604123-111717

ADDENDUM NO. 5

**Federal Aid Project Nos. CMQ-003S(390), STP-003S(390) & TAP-003S(390)
Roadway Reconstruction and Related Work along Route 126 (Pond Street)**

Transmitting revisions to the Contract Documents as follows:

STATE	FED. AID PROJ. NO.	SHEET NO.	TOTAL SHEETS
MA	CMDOT/APSTP-0035(900)	147	331
PROJECT FILE NO.		604123

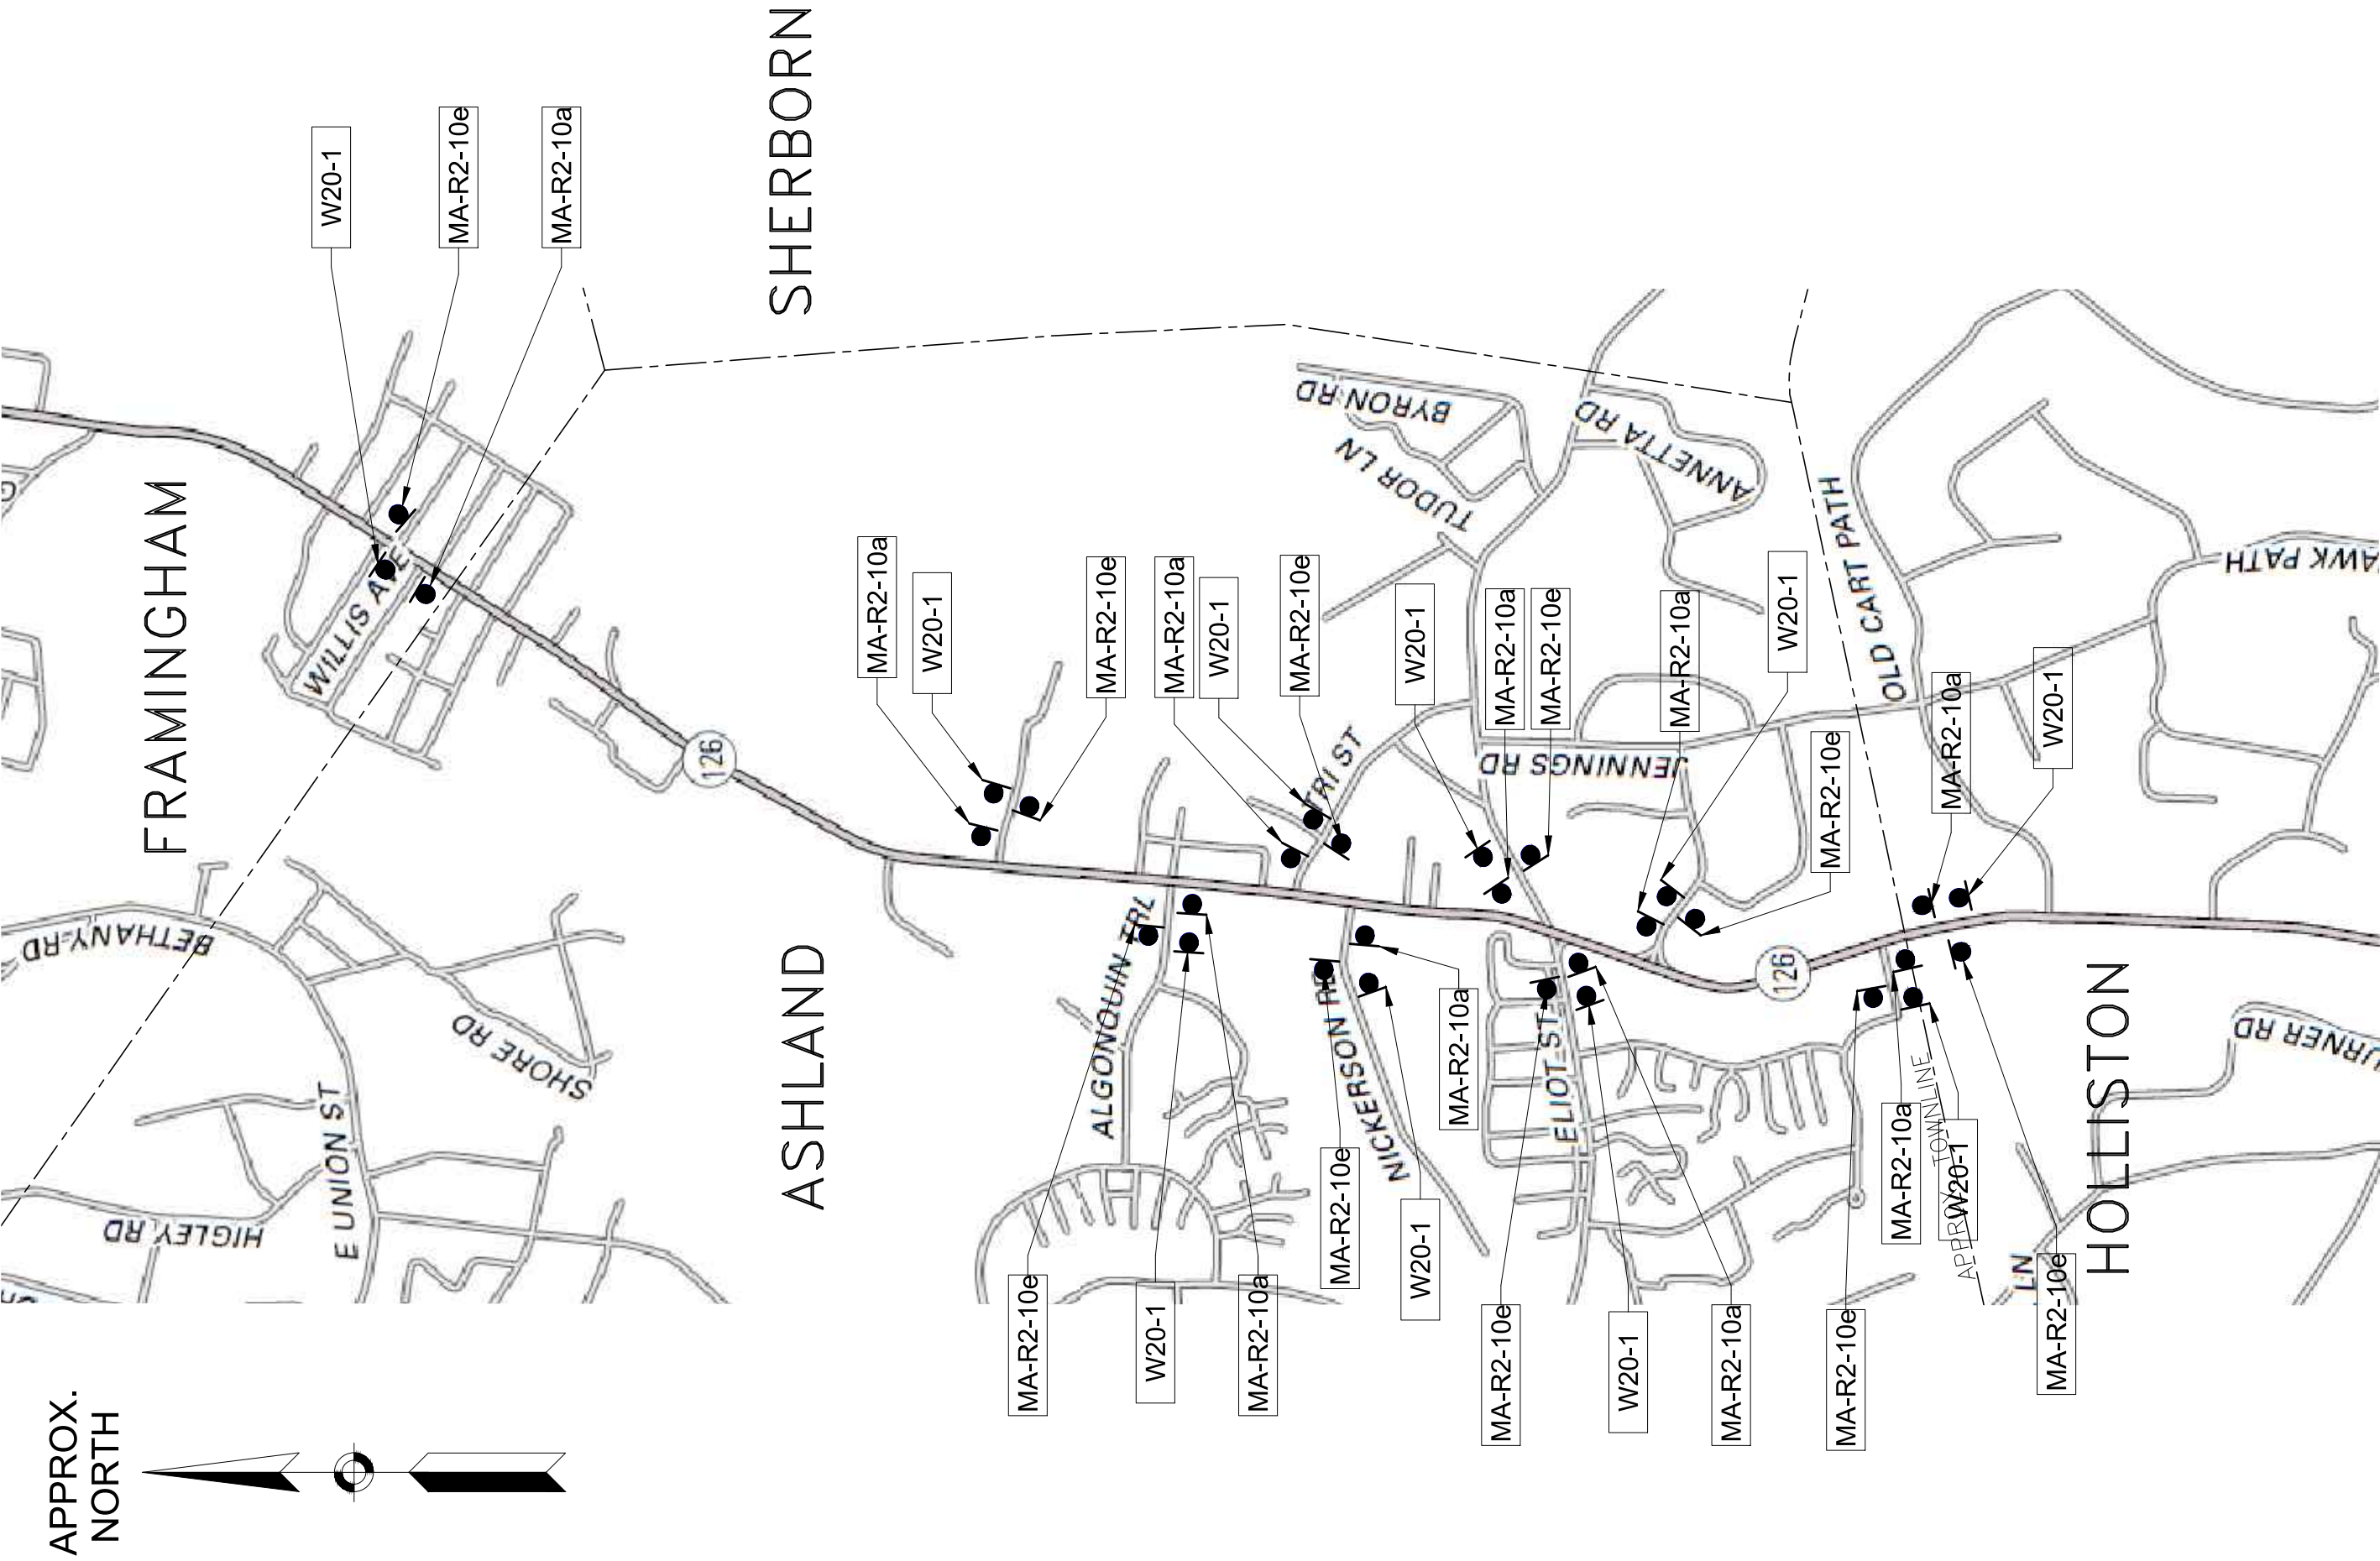
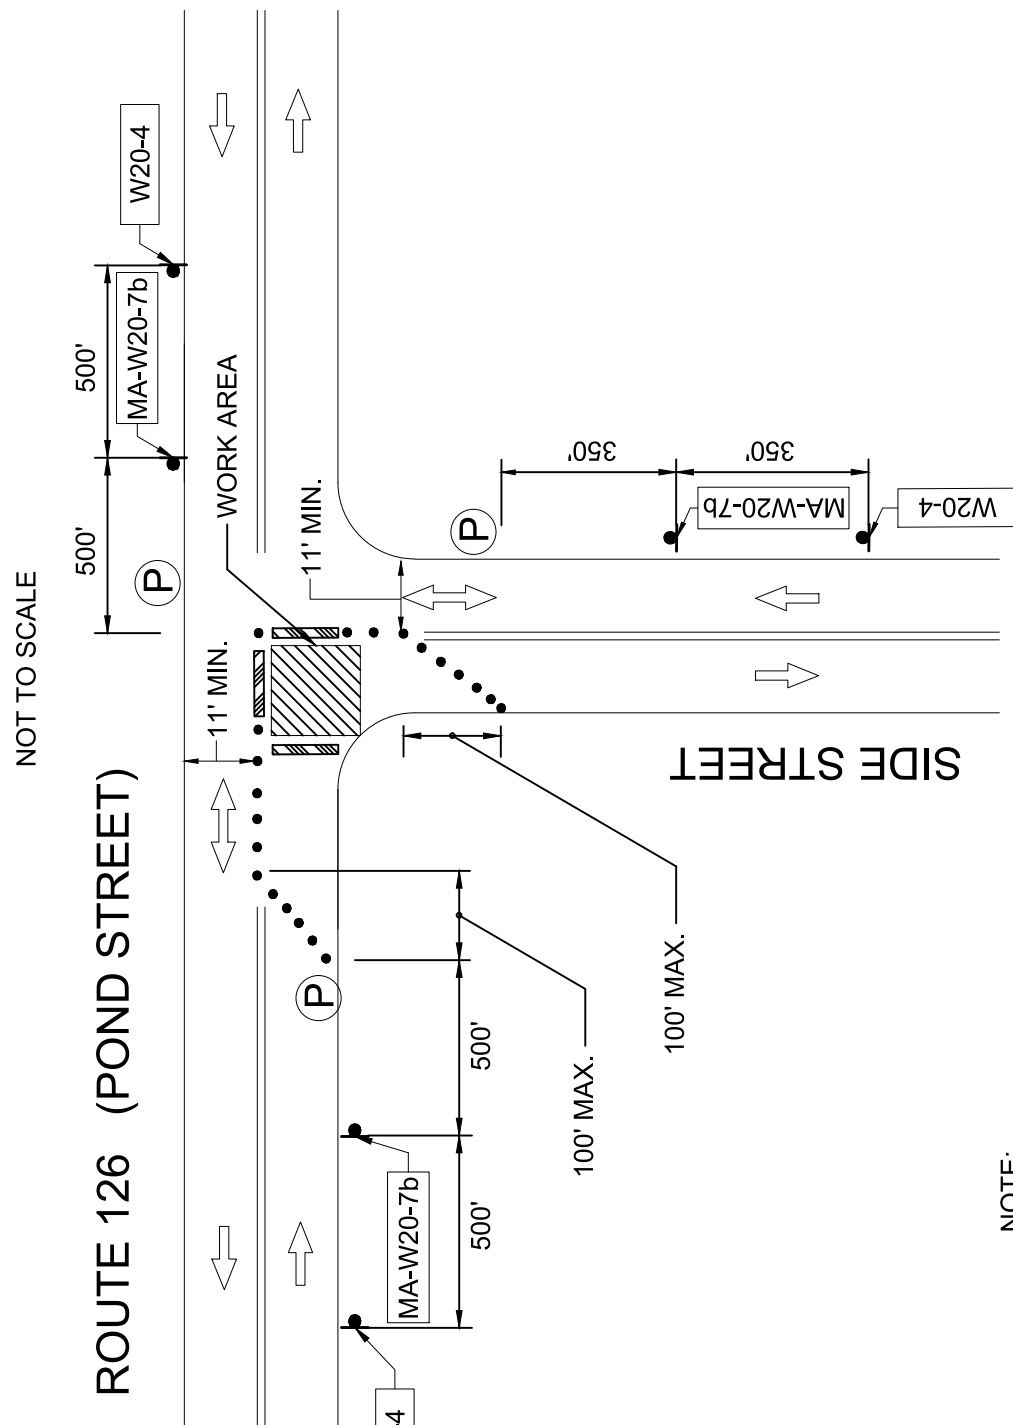
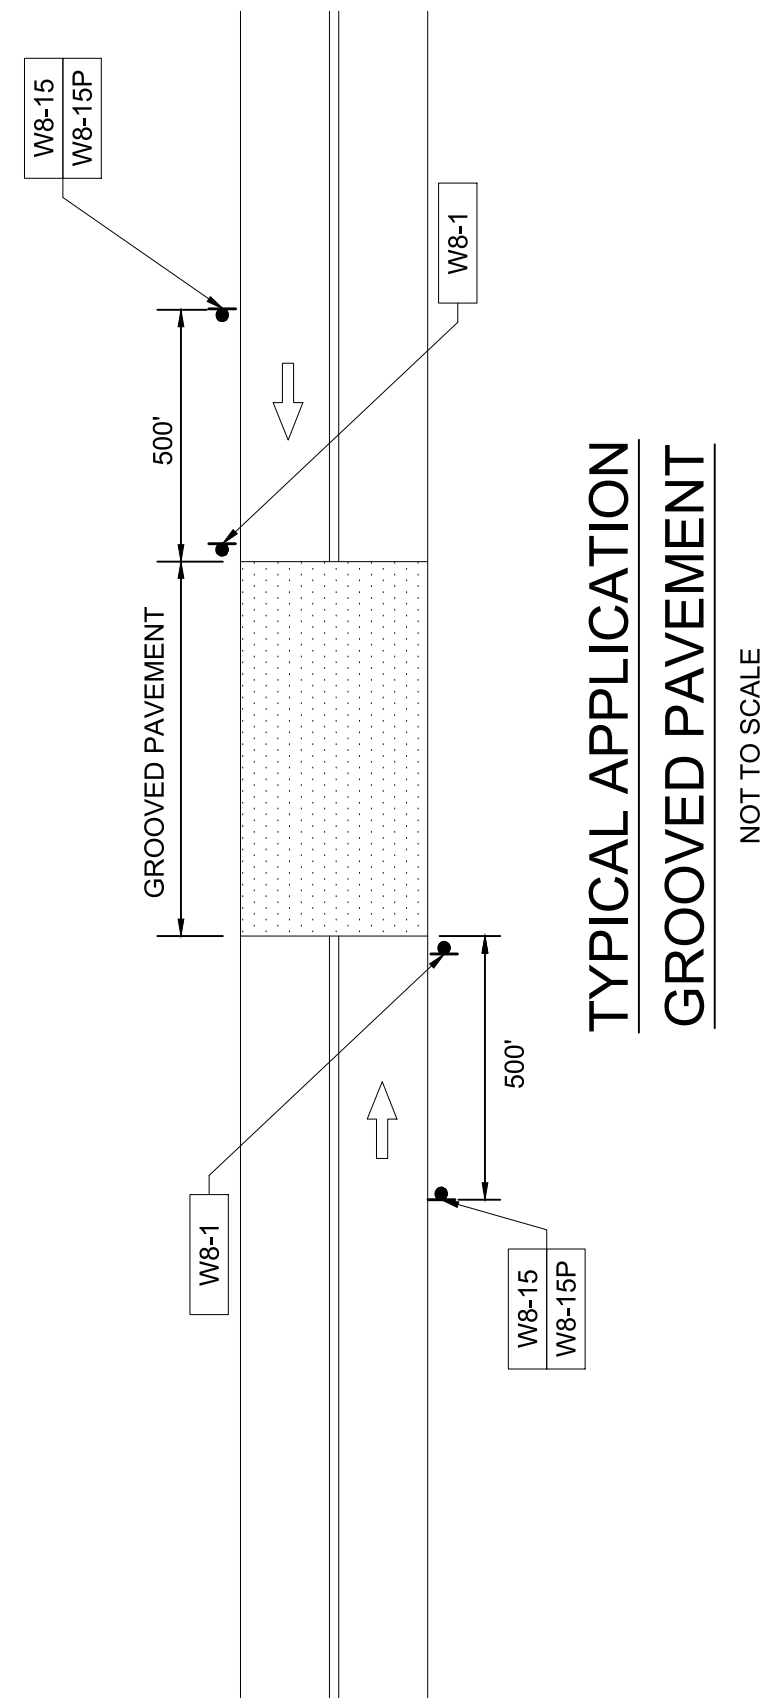
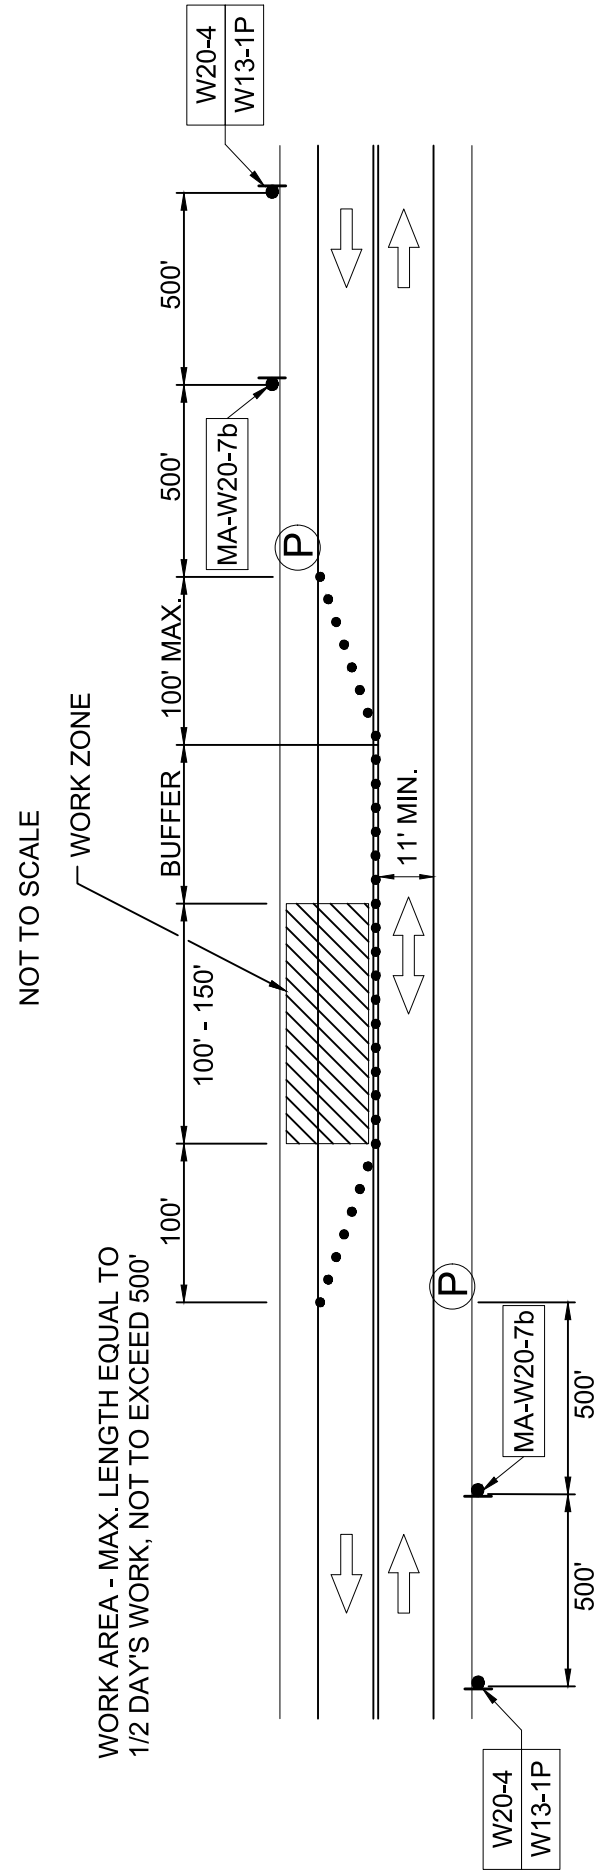
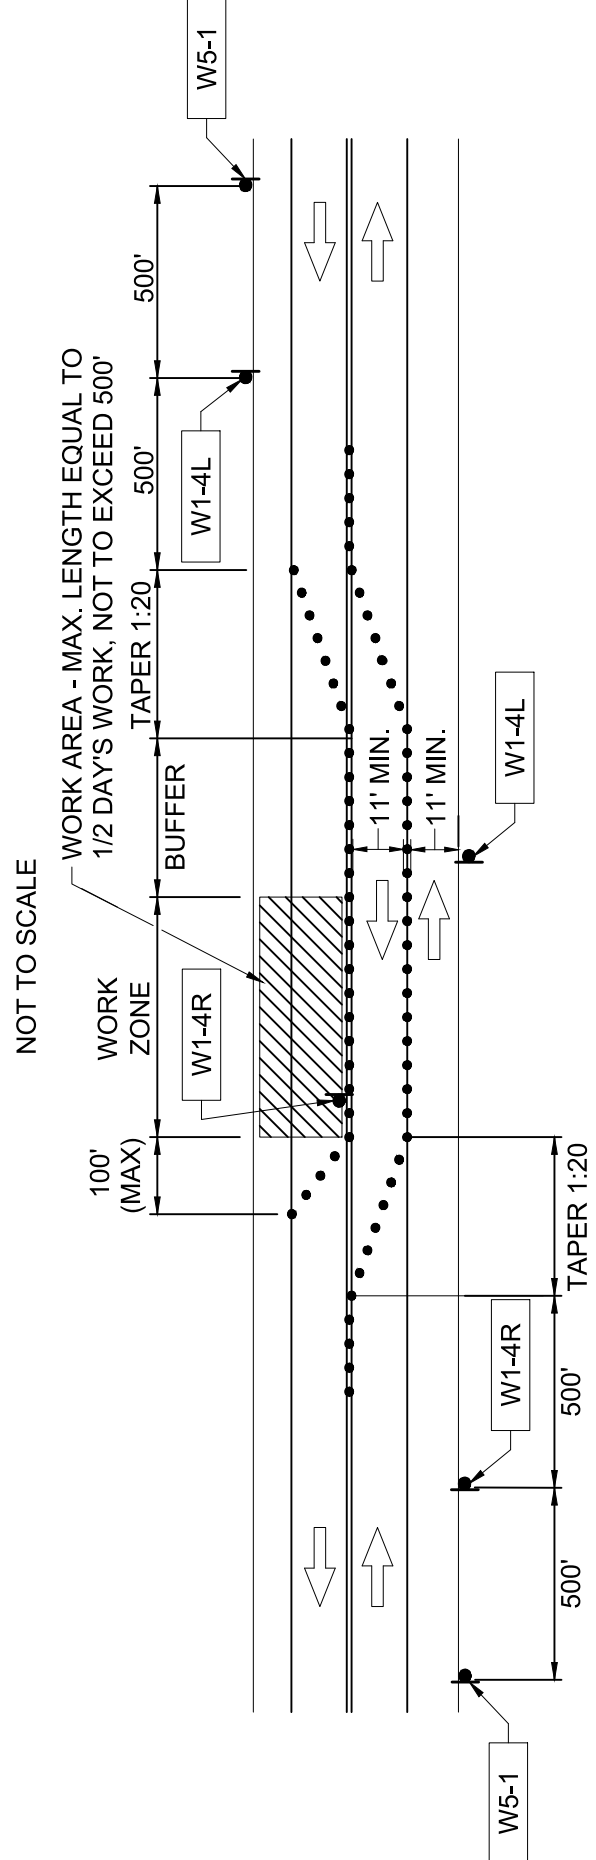
Question #23: Please provide a traffic management plan for the Spyglass retaining wall.

Response #23: The typical temporary two-lane road shoulder and/or travel lane closure application on Sheet 147 can be used as a temporary traffic management setup for the construction of the Spyglass retaining wall. See revised Sheet 147 of 331 for additional notes.
